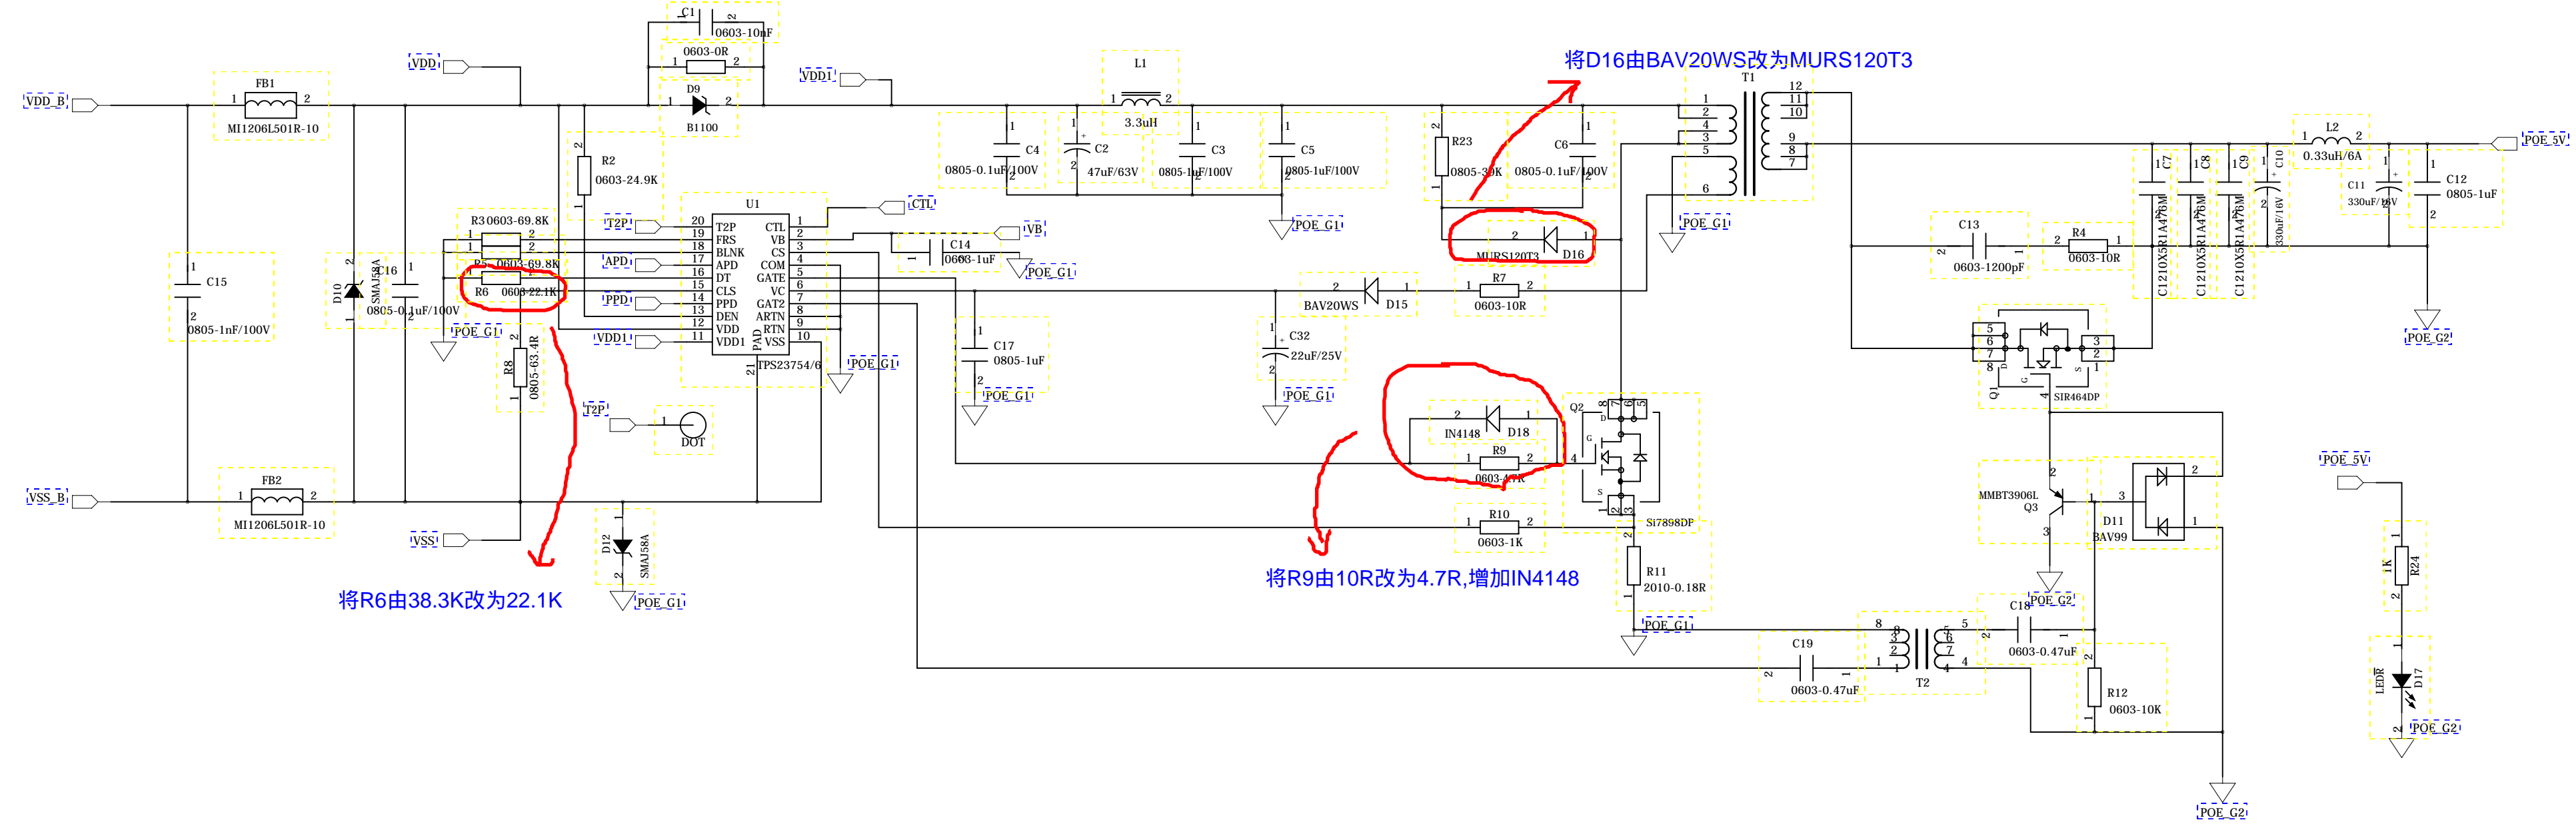
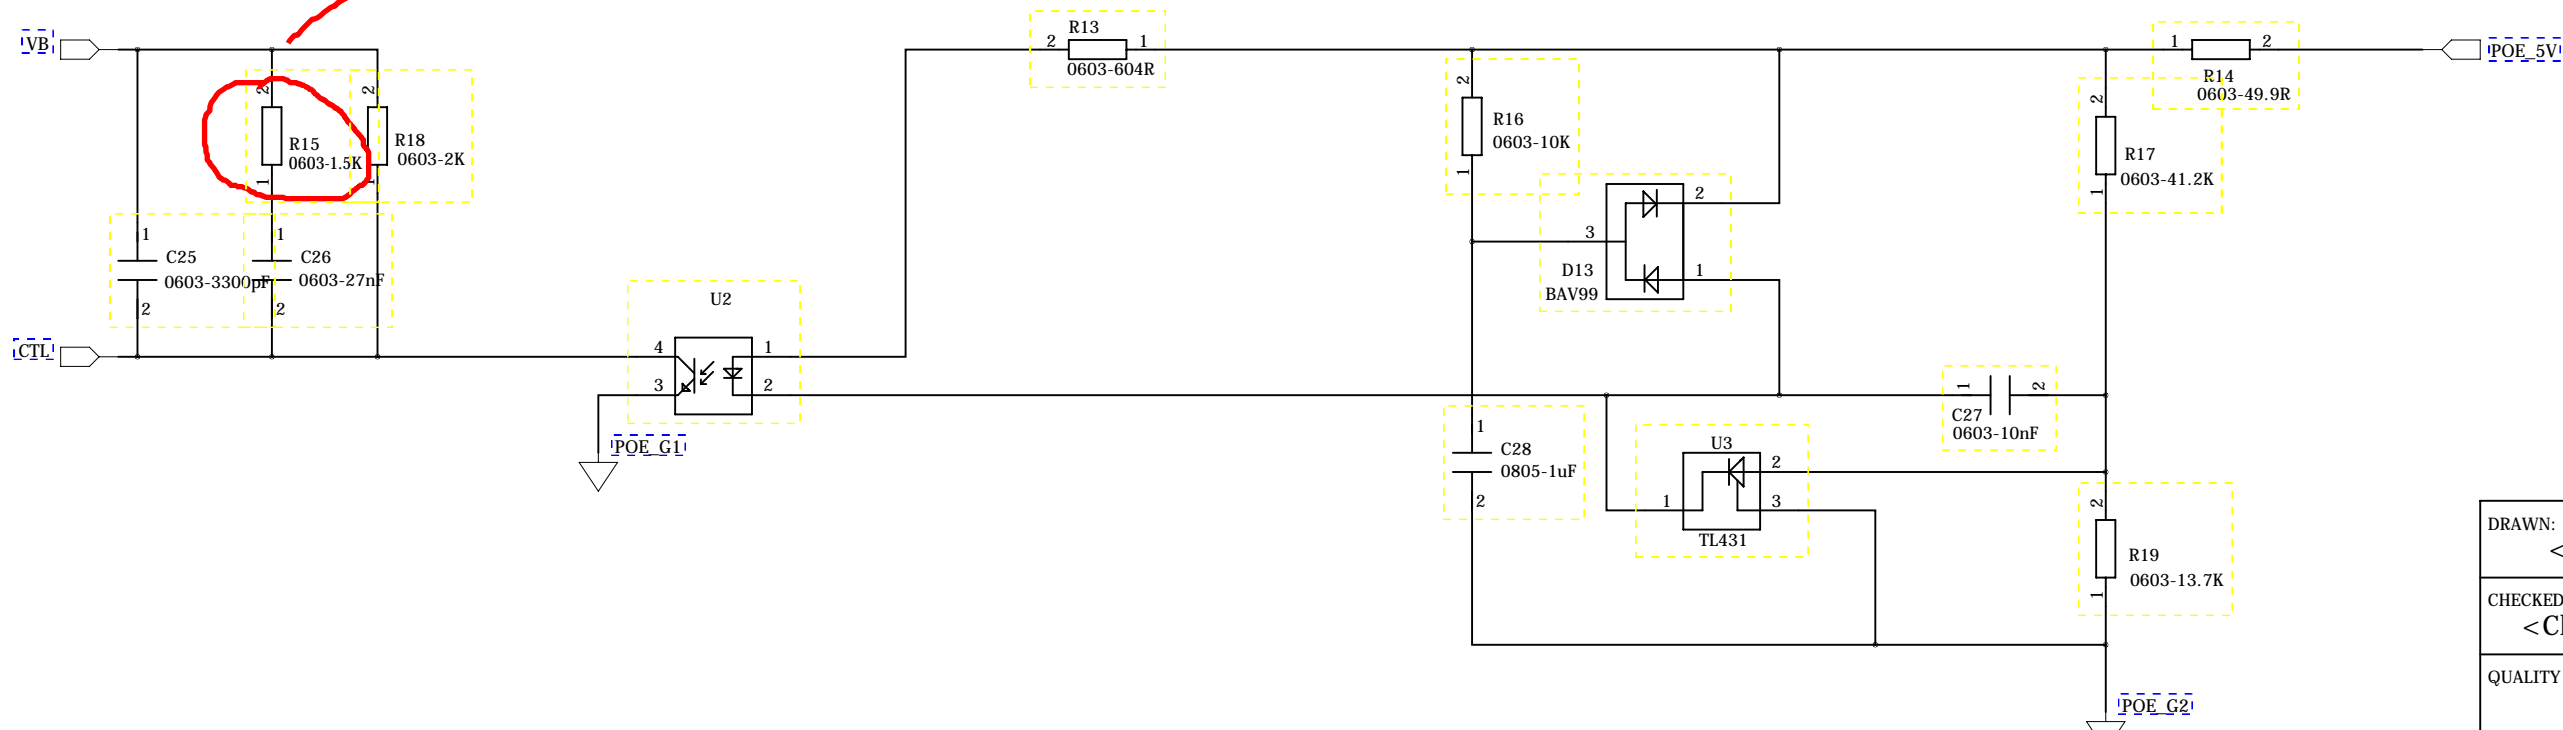
将R6由38.3K改为22.1K

将D16由BAV20WS改为MURS120T3

将R9由10R改为4.7R,增加IN4148

将R15由499R改为1.5K
